# PRE-BID CLARIFICATION FORM

PROJECT NAME:	FILLMORE HIGH SCHOOL NEW ATHLETIC COMPLEX		
PROJECT NUMBER:	Project No. 2024-017 / DSA #03-123950		
TO:	<b>RJ Stump</b> EMAIL: <a href="mailto:rj.stump@fillmoreusd.org">rj.stump@fillmoreusd.org</a> <b>Fillmore Unified School Dist.</b>  <b>Roy Frey</b> <b>WestGroup Designs</b> <a href="mailto:royf@westgroupdesigns.com">royf@westgroupdesigns.com</a>		
DATE:	February 21, 2025		
FROM:	Icon West, Inc. 520 S. La Fayette Park Pl, Suite 503 Los Angeles, CA 90057	EMAIL:	<a href="mailto:felix@icon-west.com">felix@icon-west.com</a>
DOCUMENT/DIVISION NUMBER:	Sec 053100 - Base Bid	DRAWING NUMBER:	S0-07 - Base Bid

LOW ROOF FRAMING PLAN

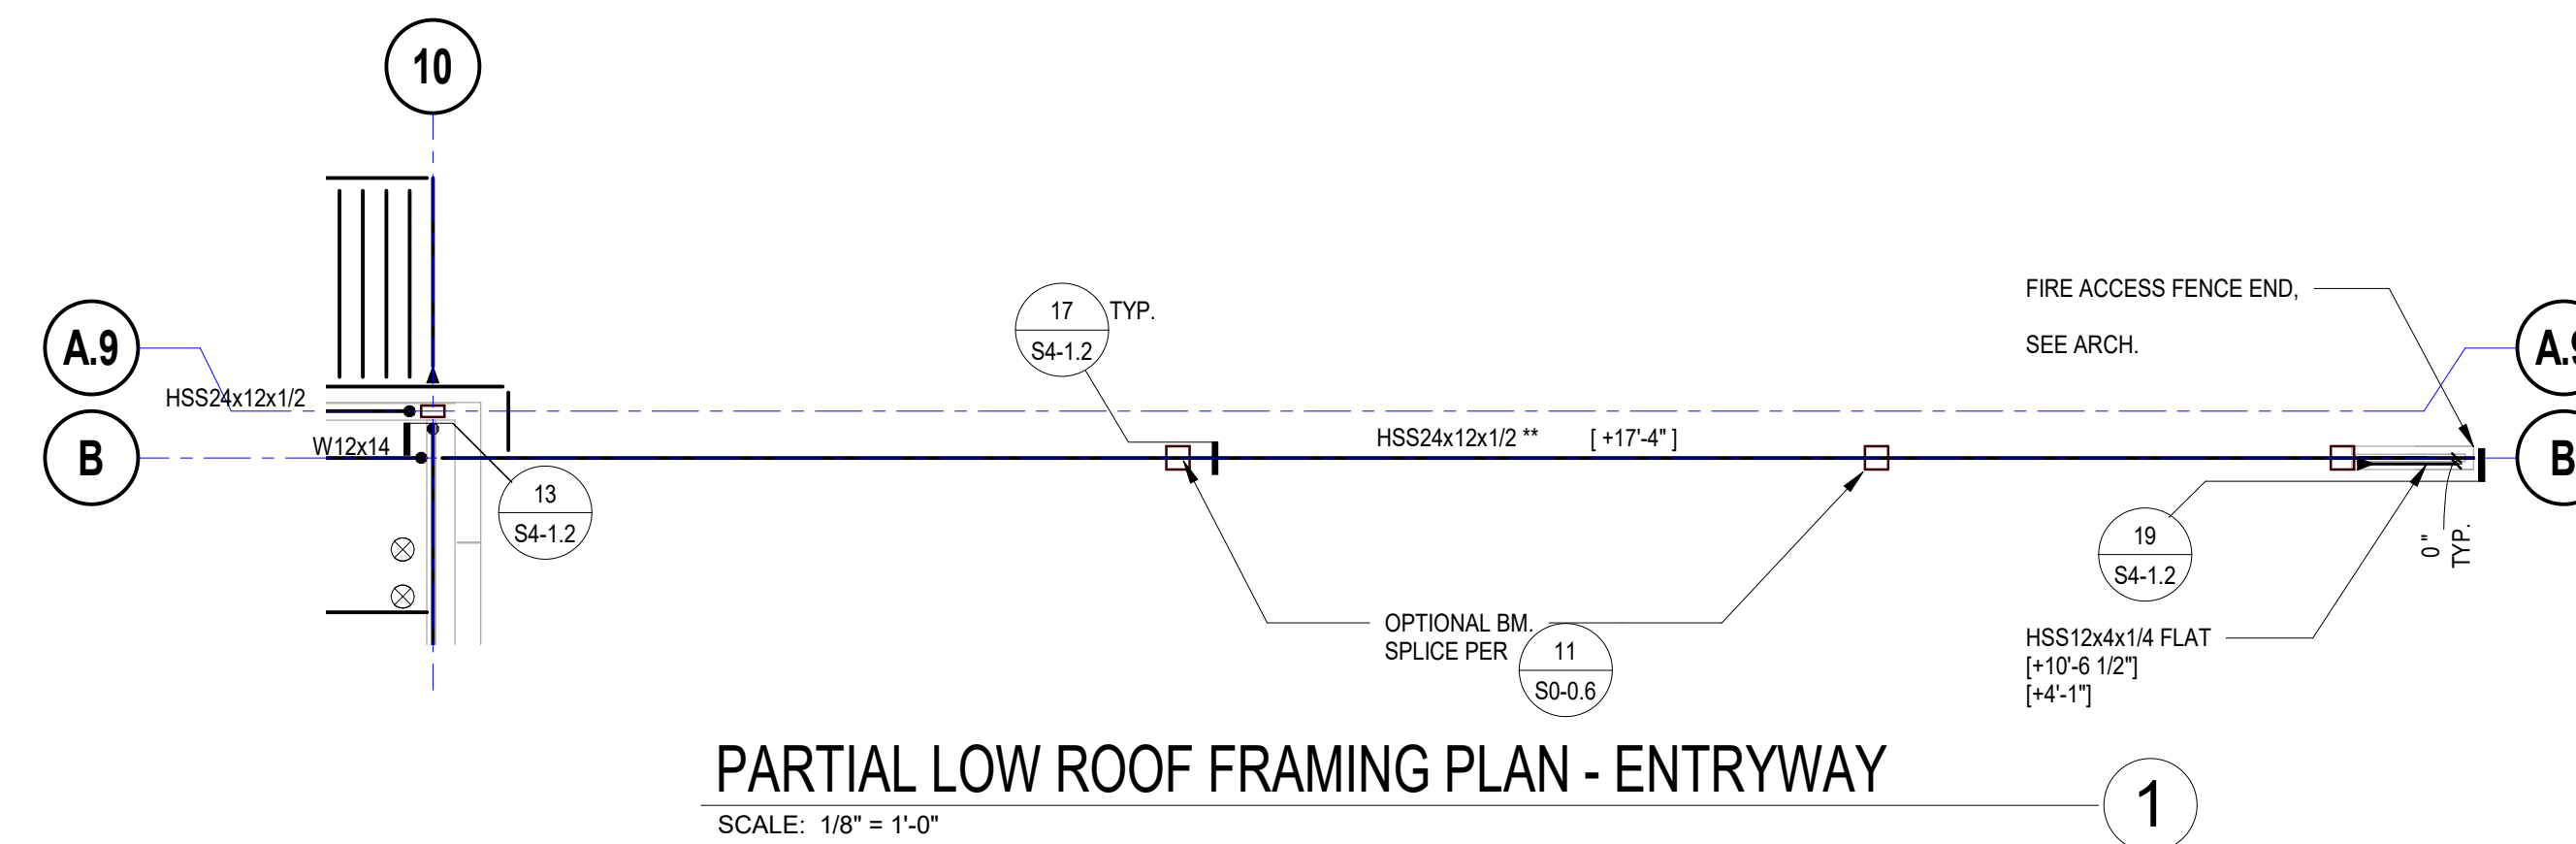
There seems to be tube steel members that assist in framing the decorative parapet wall system as seen in architectural sections sim. to sheets A4-3.1, A4-3.3 & A4-3.5. Structural details for this seem to be the following: 1,2,5,10,22,24/S4-1.1; 2,/S4-1.2; 2,4,7/S4-1.3. To clarify the intent of the steel above the metal deck level, is it possible to request a complete plan and elevation view of all the steel above the metal deck elevation? This would help identify where the steel is located and what the steel members are along with how the steel is connected.

**REFLECTED CEILING PLAN**

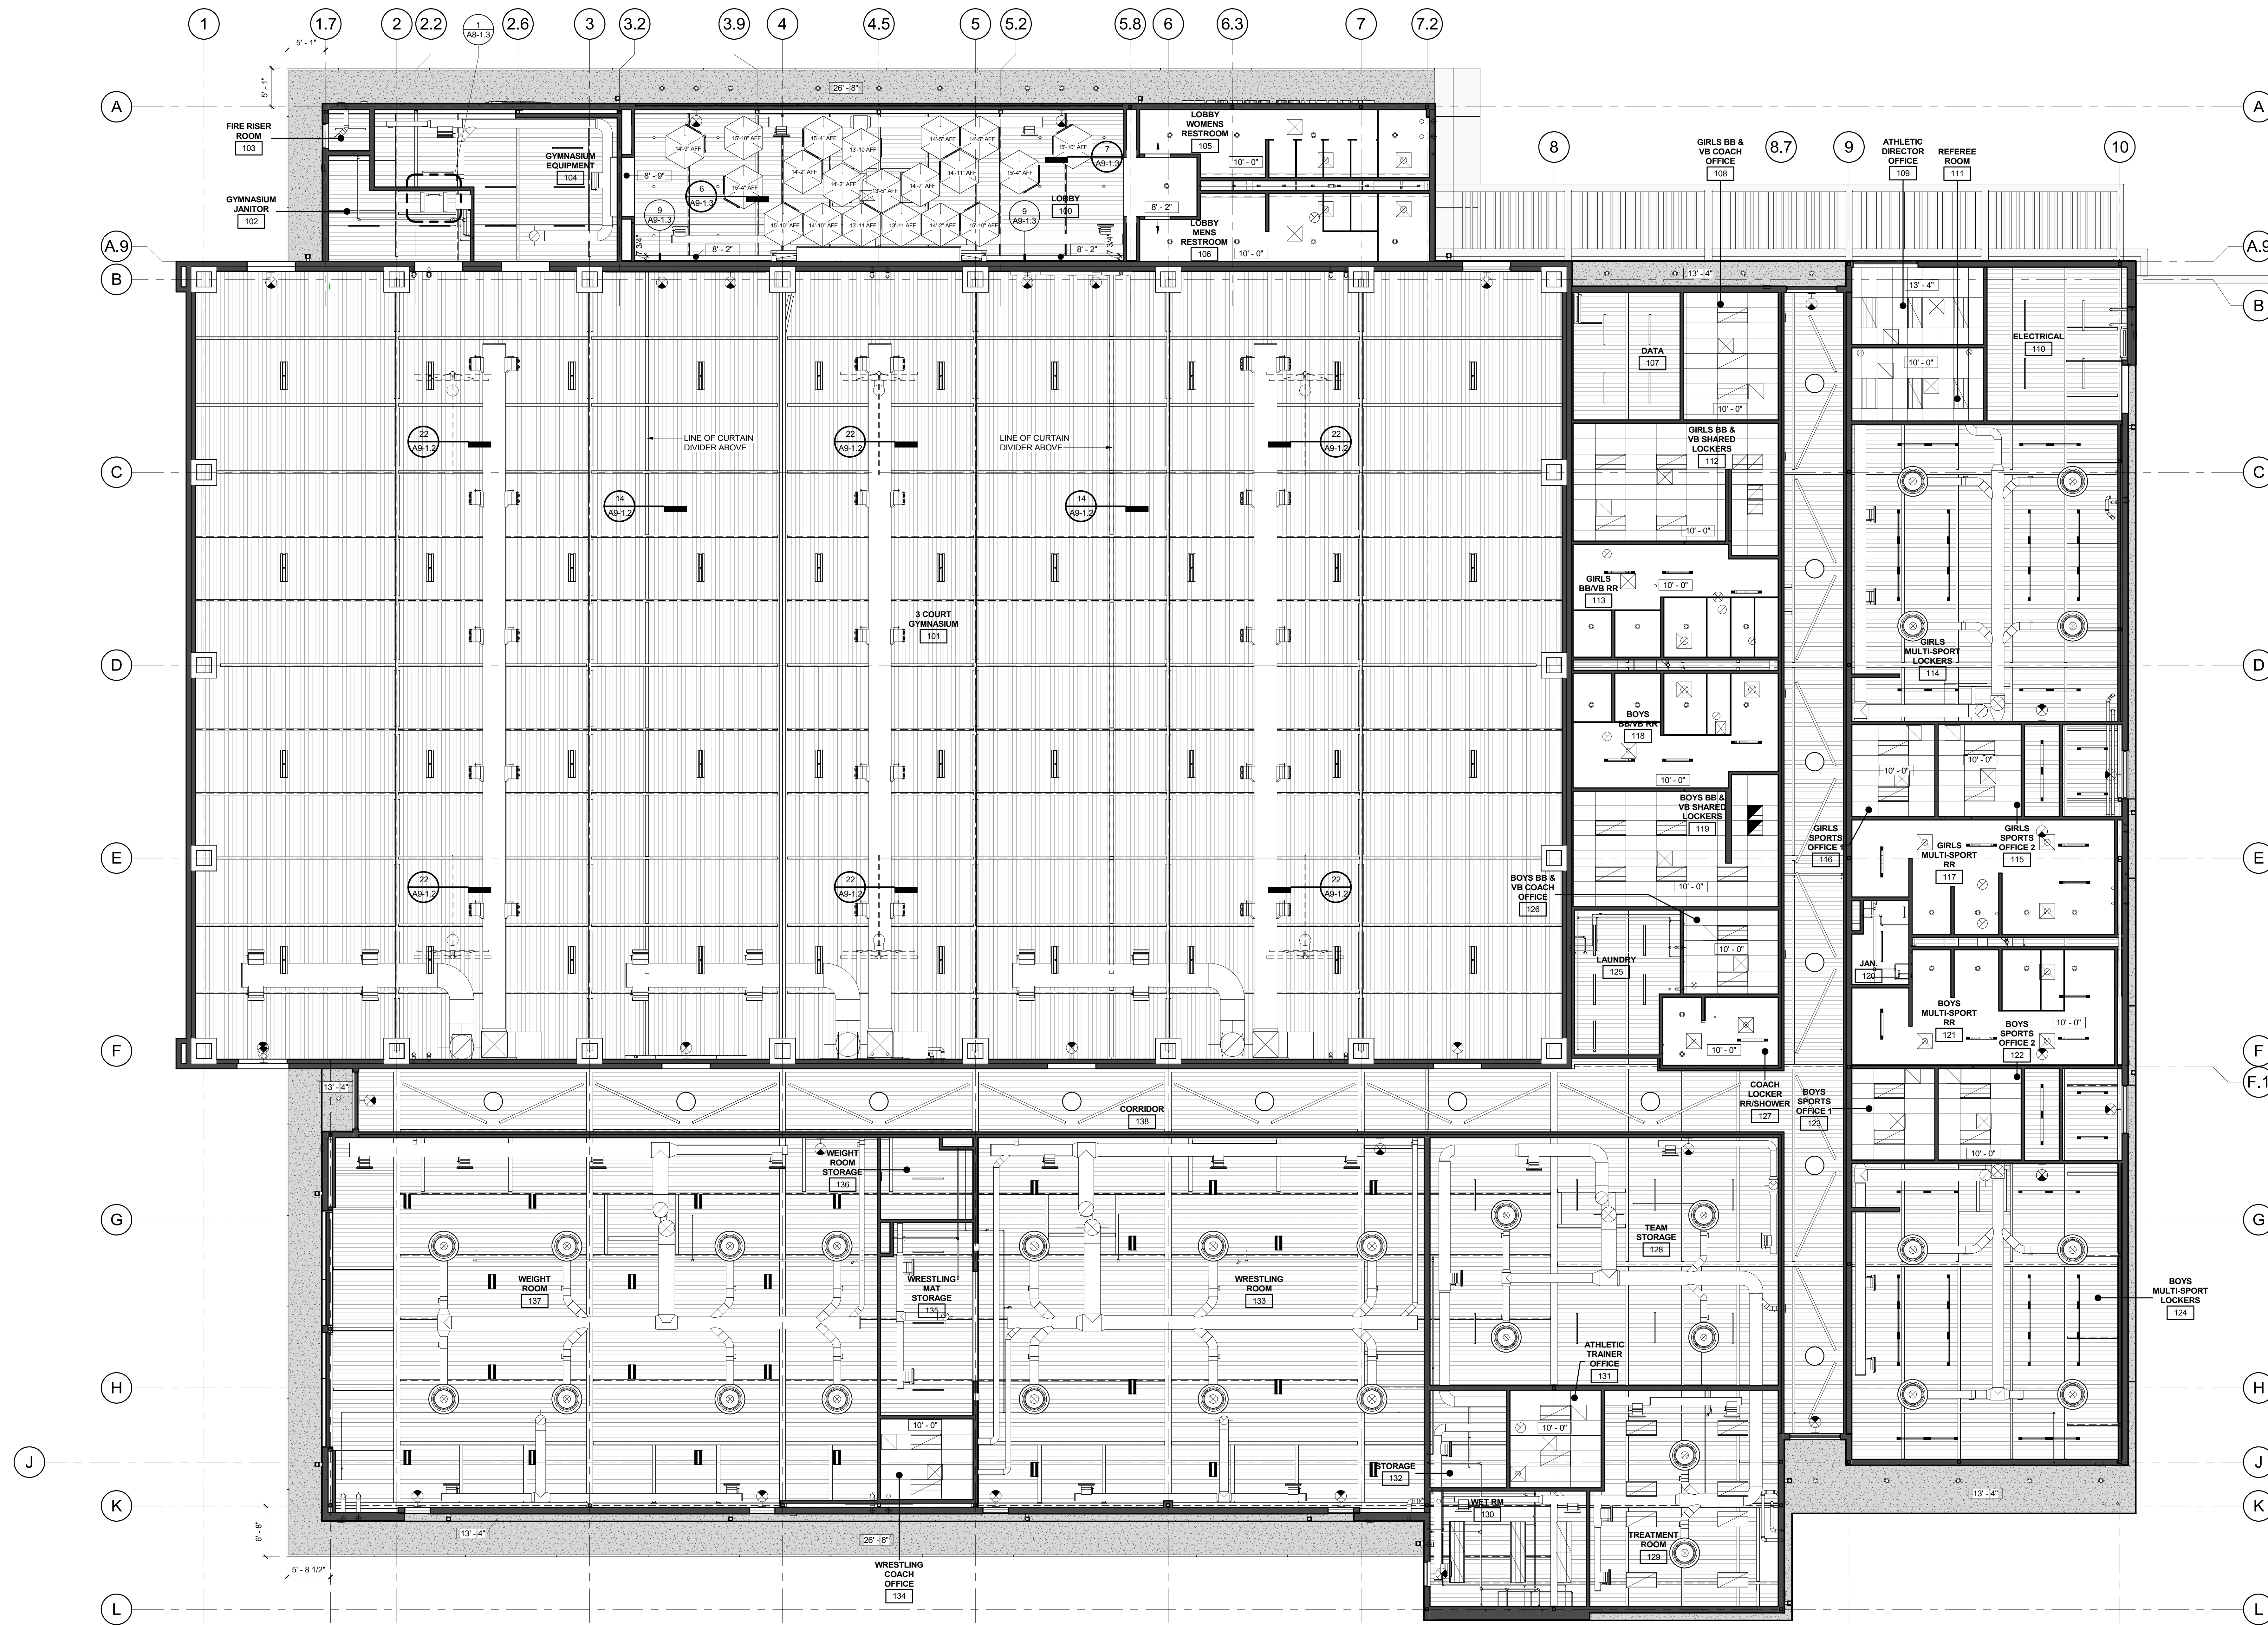
REQUESTED CLARIFICATION:
<p><b>Please circle all applicable bid packages below, that this RFI pertains to:</b></p> <p><b>Base bid</b></p> <p>Alt #1</p> <p>Alt #2</p> <p>Specification section 09 96 00 calls out steel decking to receive a high-performance coating, while specification section 09 90 00 calls out exposed building structure to receive Latex dry fall, flat, Aquafall AQUA10, and the reflected ceiling plan calls out the exposed decking to receive "P2" (Dunn-Edwards DEHW09 Be Cool paint). Please advise which finish the exposed decking receives.</p> <p><b>Response:</b>          The steel decking is on the interior of the building and where exposed is to receive paint color P4 (Dunn-Edwards DEA002 Black) with the type of paint to be Aquafall AQUA10. See revised sheet A3-1.1 attached</p> <p>There is no exterior steel decking on the project that would need the high-performance coating.</p>

TRASH ENCLOSURE EAST

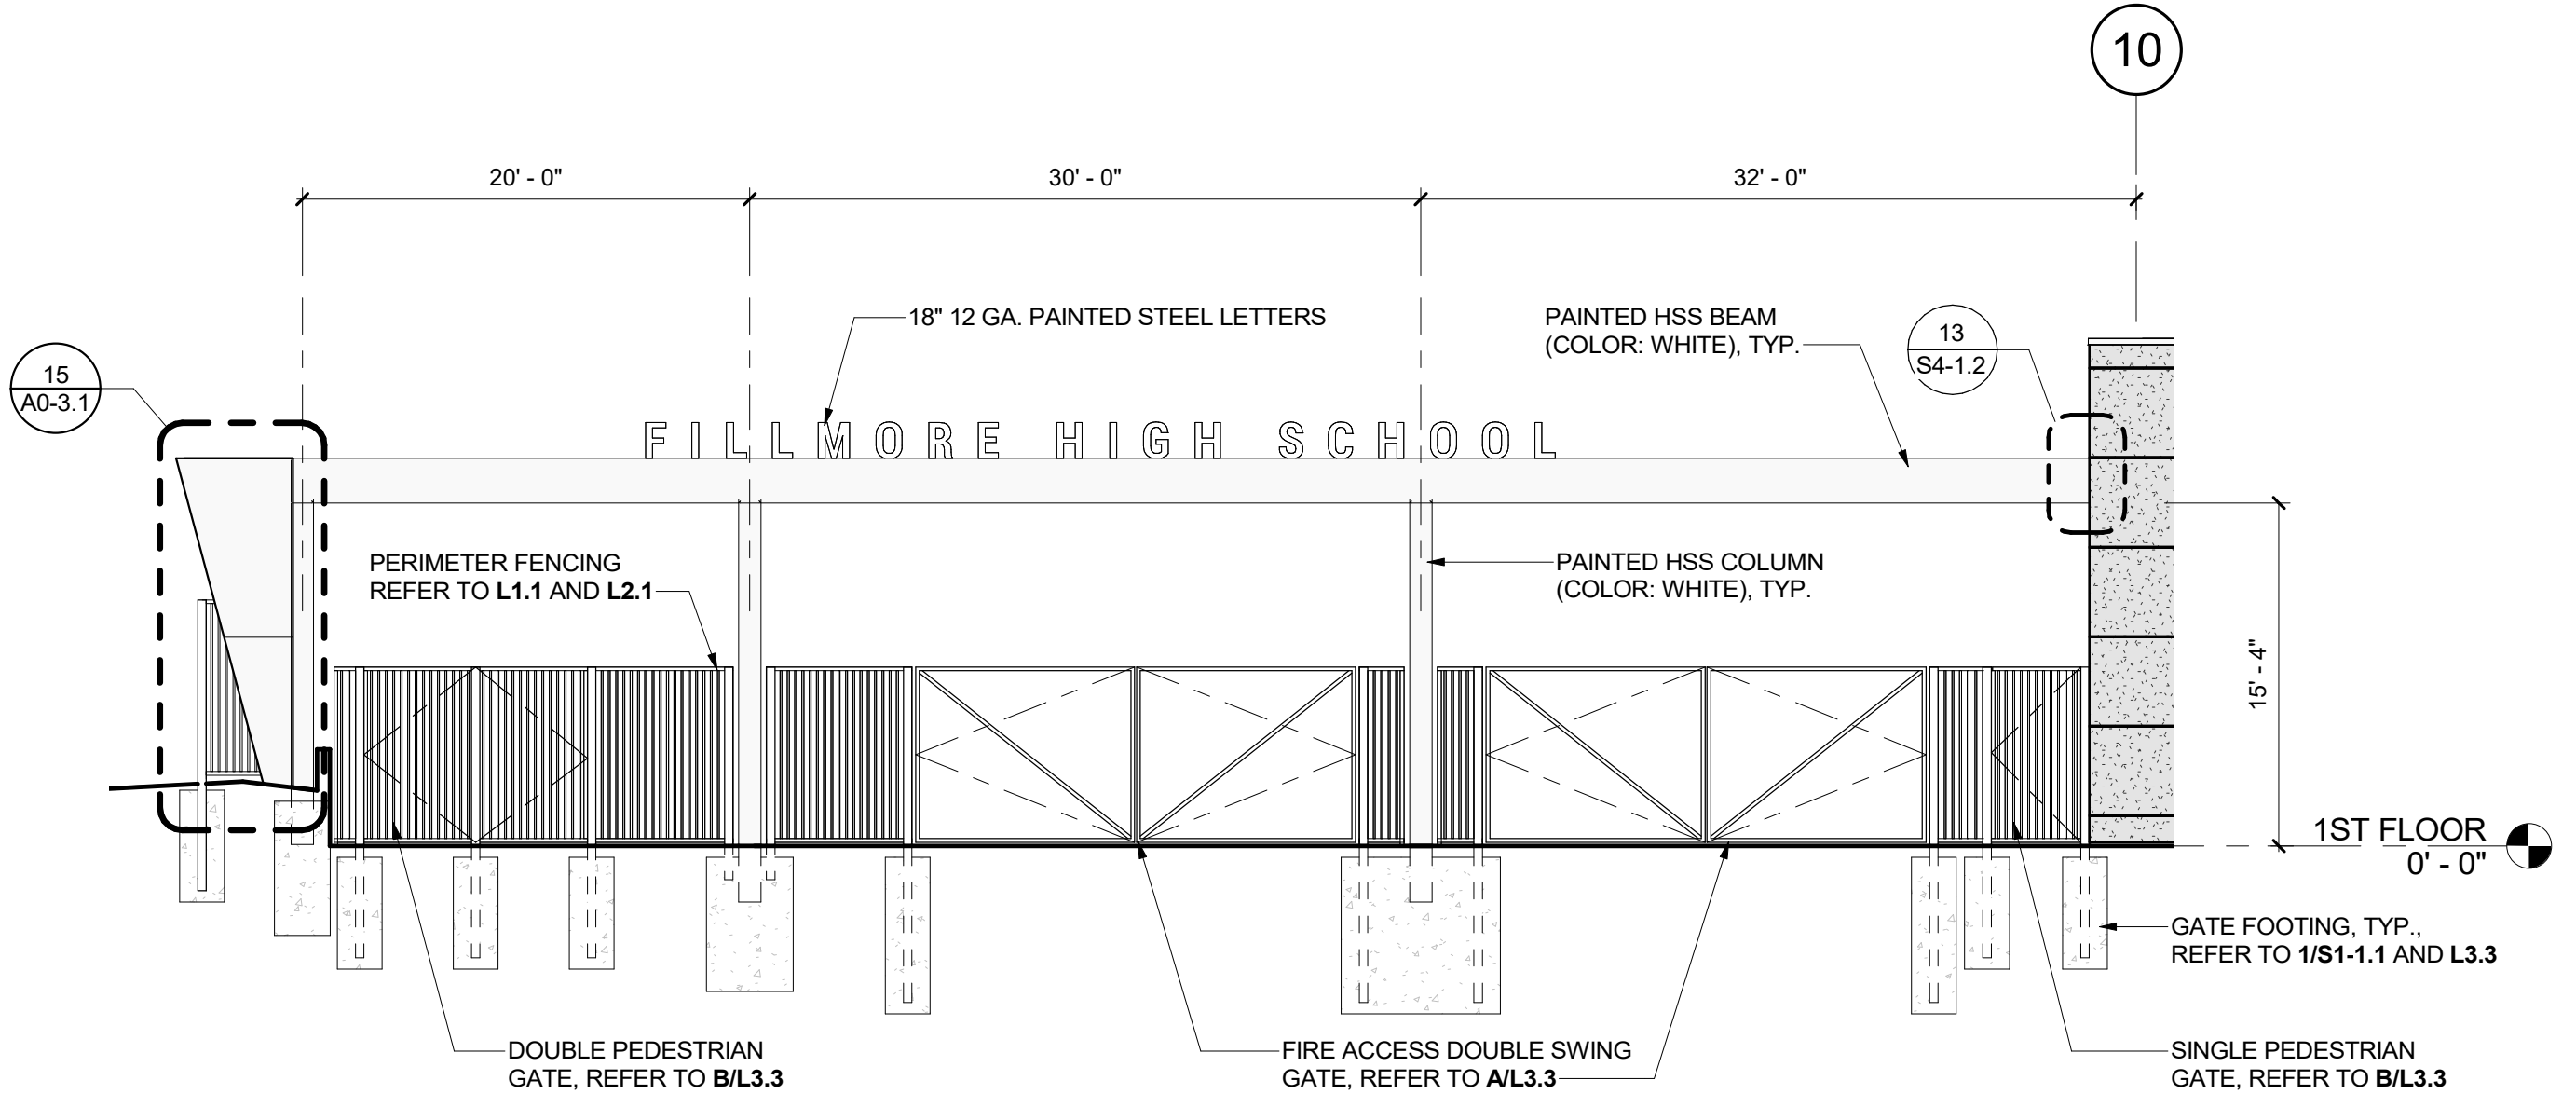
The Trash Enclosure, shown on sheet No. A0-3.1 does not indicate the type of texture or color of the CMU. Please advise.

1. Trash enclosure CMU type and texture called out on revised sheet. See revised spec section for unit masonry. See attached A3/A0-3.1 for trash enclosure CMU color and texture.
